Access Compliance Report

Public Rights-of-Way

(Curb Ramps)

Intersection ID: 52112	Main Street: YOUNGBLOOD_ST	Cross Street: POINDEXTER_DR	Location: S
ADA ID: FD9CC15098C1	Ramp Type: Perp	Initial Pass/Fail: Fail	Overall Compliance: No
Severity Score: 12.5			
Codes/Mitigation Info/Possible Solution		Field Measurements/Component Compliance

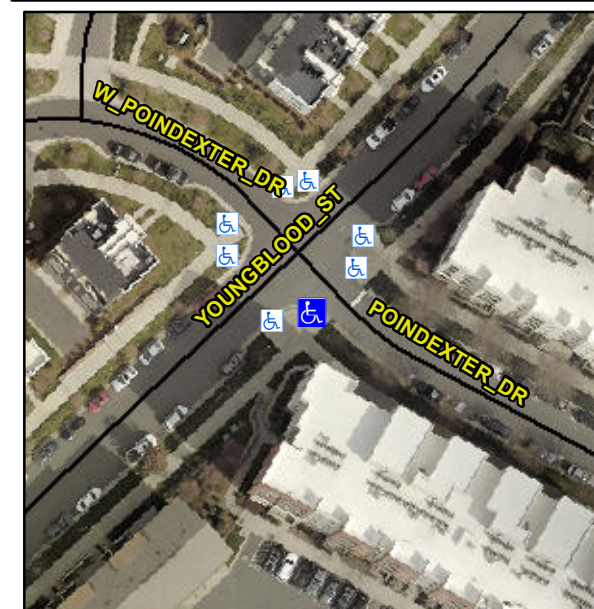
Not Found, R304.2.2

Compliance	Description	Data	Compliance	Description	Data
N/A	Ramp Length (in)	75.0	No	Ramp Slope (%)	10.2
Yes	Ramp Width (in)	48.0	Yes	Ramp XSlope (%)	0.8
N/A	Flare Type LT	N/A	N/A	Flare Type RT	N/A
N/A	Flare Slope LT (%)	N/A	N/A	Flare Slope RT (%)	N/A
N/A	Flare Traversable LT?	N/A	N/A	Flare Traversable RT?	N/A
N/A	Landing Length (in)	N/A	N/A	DWS Provided?	N/A
N/A	Landing Width (in)	N/A	N/A	DWS Contrast?	N/A
N/A	Landing Slope (%)	N/A	N/A	DWS Length (in)	N/A
N/A	Landing X Slope (%)	N/A	N/A	DWS Full Width?	N/A
N/A	Landing Curb? (Y/N)	N/A	N/A	DWS Offset (in)	N/A
N/A	Shared Landing?	N/A			
N/A	Gutter Ponding?	N/A	N/A	Gutter Slope (%)	N/A
N/A	Gutter Lip Ht (in)	N/A	N/A	Gutter X Slope (%)	N/A
N/A	Painted X Walk1?	No	N/A	Painted X Walk2?	N/A
	X Walk 1 Direction	To NE		X Walk 2 Direction	N/A
N/A	X Walk 1 Width (in)	N/A	N/A	X Walk 2 Width (in)	N/A
	X Walk 1 Slope (%)	1.4		X Walk 2 Slope (%)	N/A
	X Walk 1 X Slope (%)	2.5		X Walk 2 X Slope (%)	N/A

Remove & Replace Entire Ramp.
